Groundwater Application Review Summary Form

Application # G- 19280

GW Reviewer Darrick E. Boschmann Date Review Completed: 07/02/2025

A. GENERAL INFORMATION: Applicant's Name: White Sage Land and Cattle CO. LLC County: Harney

Water-Level Measurements in Nearby Wells

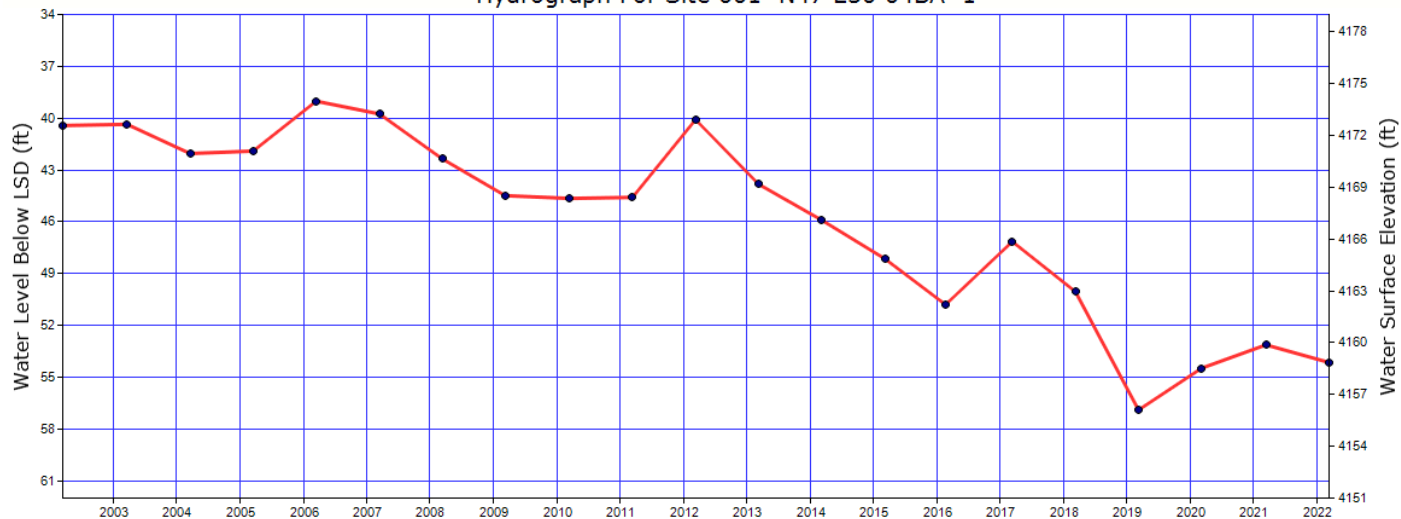
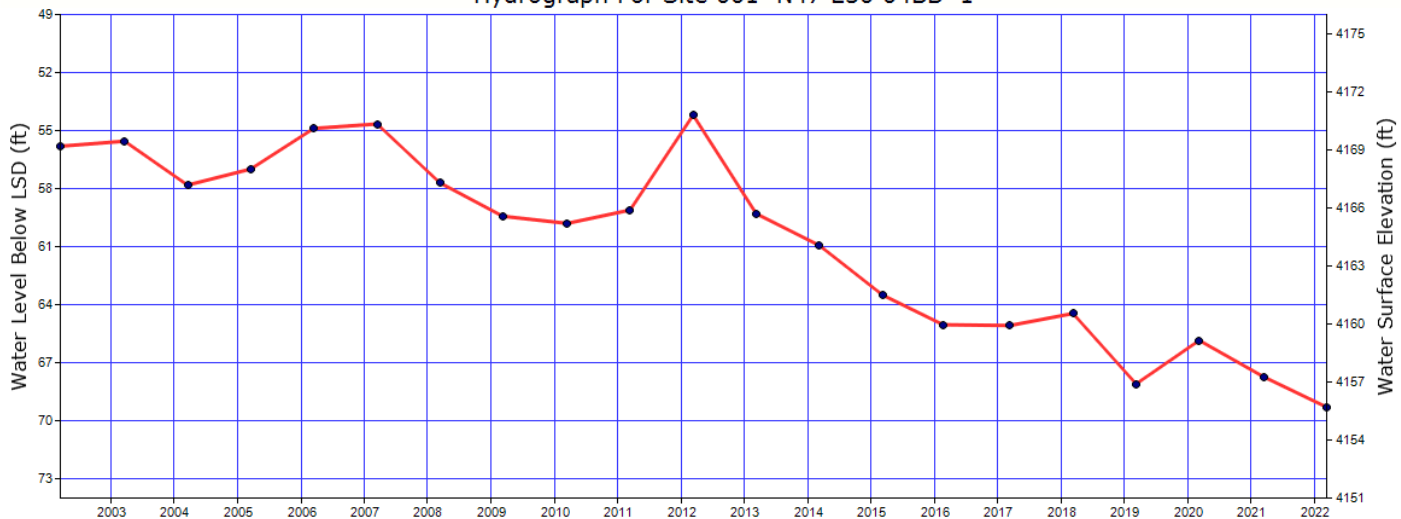
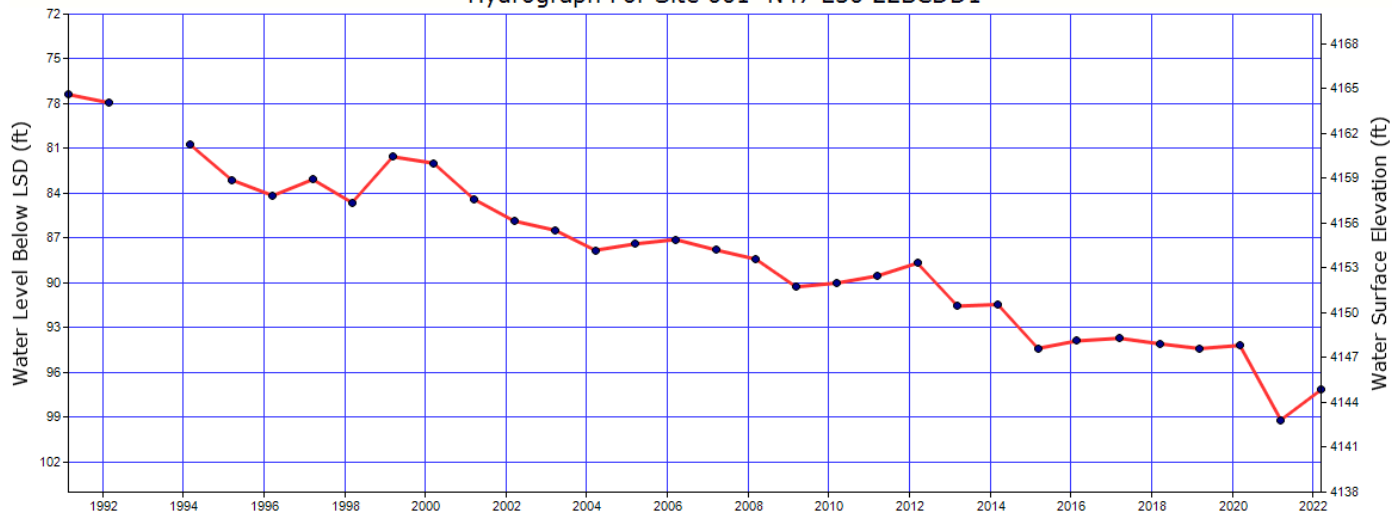
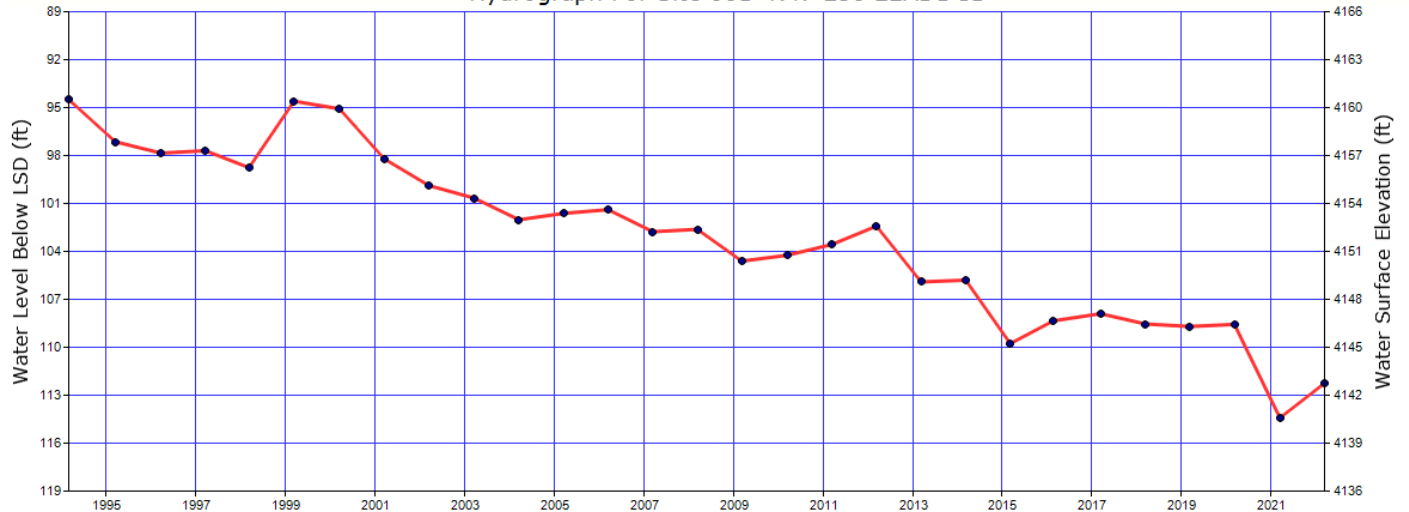
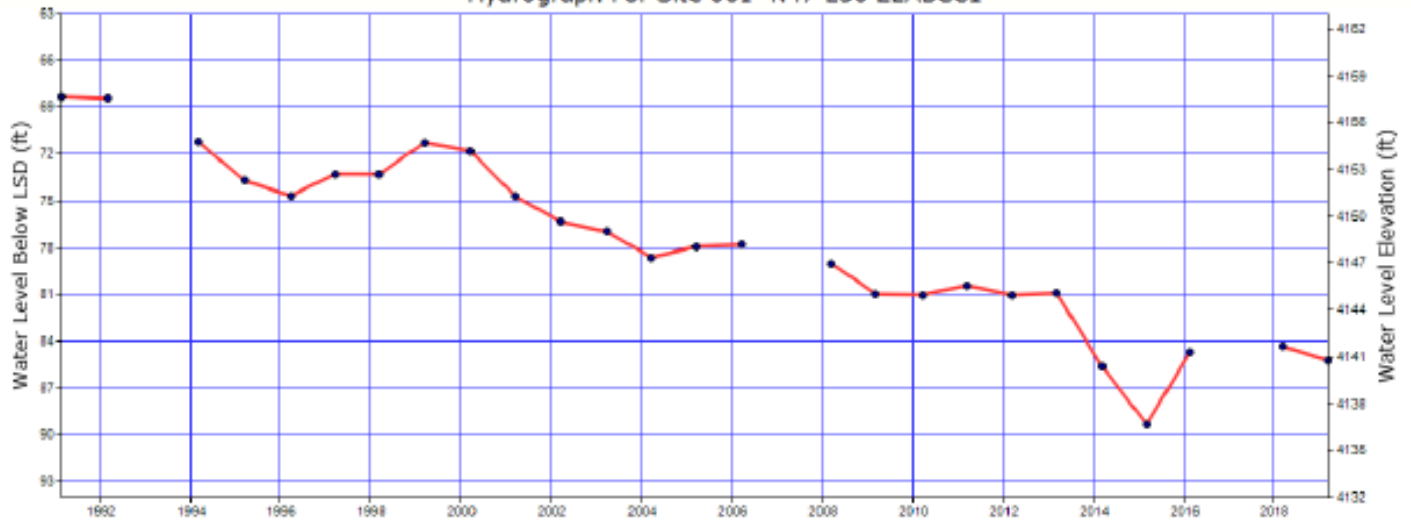
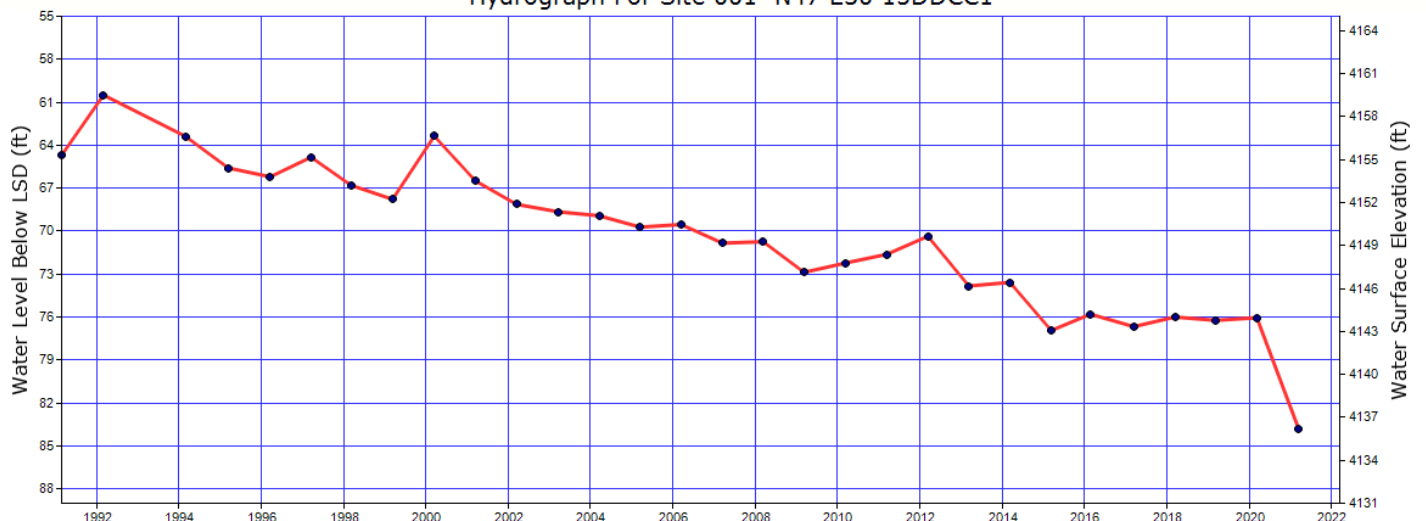
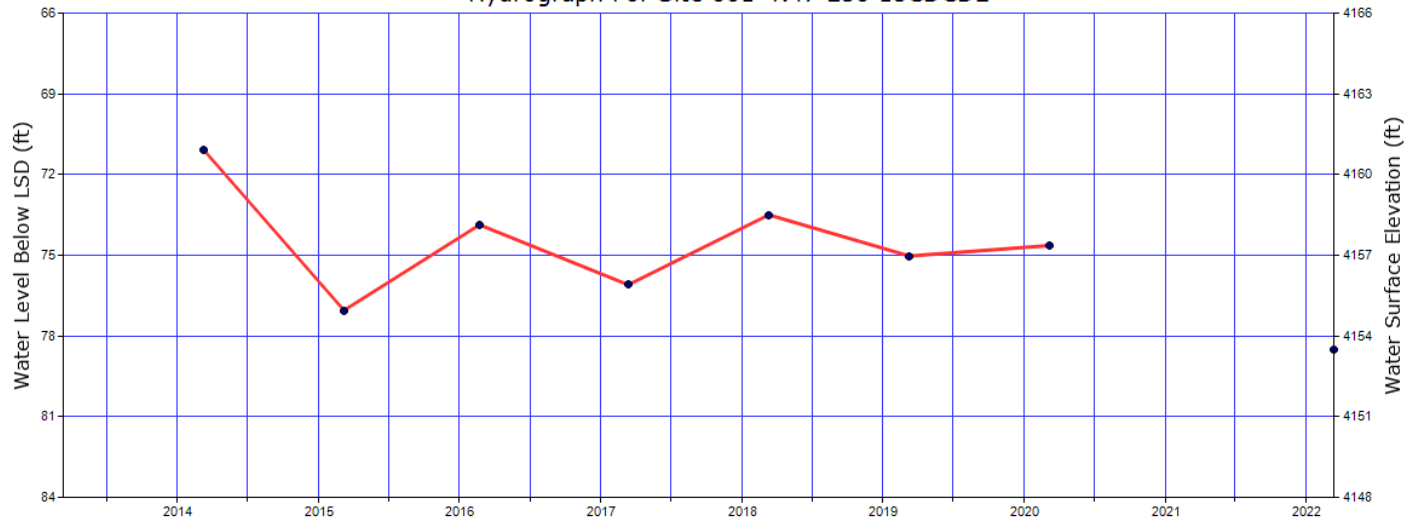
Elsewhere in the Pueblo Valley, including further south on the Nevada side of the border, water level records associated with areas of groundwater development indicate water level declines over the available period of record. While these records may not be representative of groundwater conditions in the immediate vicinity of the proposed groundwater development, they may be indicative of the effect of groundwater development within the Pueblo Valley.

The proposed project area has similar climate and underlying geology as other areas within the Pueblo Valley that are experiencing water level declines in response to groundwater development. Issuance of a permit for groundwater withdrawals

at the rate and duty proposed here will likely contribute to these water level declines and could impair the function of the aquifer by precluding its perpetual use. Therefore, the proposed use is found to be not within the capacity of the resource as defined in OAR 690-400-0010.

Transient Stream Depletion (Jenkins, 1970; Hunt, 1999, 2003)

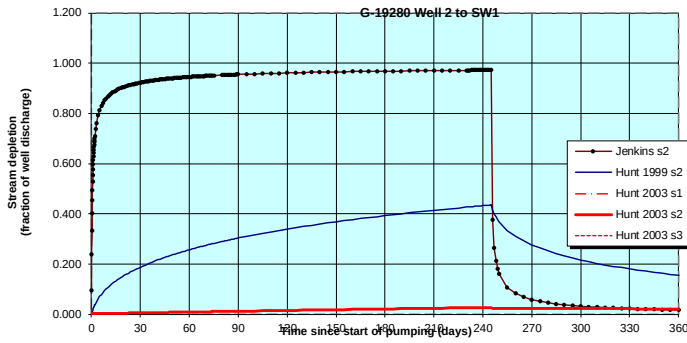
Hunt (2003) was used to calculate the interference between the proposed wells within a mile of hydraulically connected surface water. Very little data is available about aquifer parameters at this location. The values used for the calculation are conservative and appropriate until better values become available. The calculations used the average transmissivity derived from pump tests on two nearby wells (HARN 1819; HARN 1818) (7,976 ft²/day). Additionally, the calculation used an assumed intermediate storage coefficient (0.001). The pumping rate used is the maximum rate proposed for the application (3.0 cfs). Interference is less than 25% at 30 days in all cases. See reports attached.
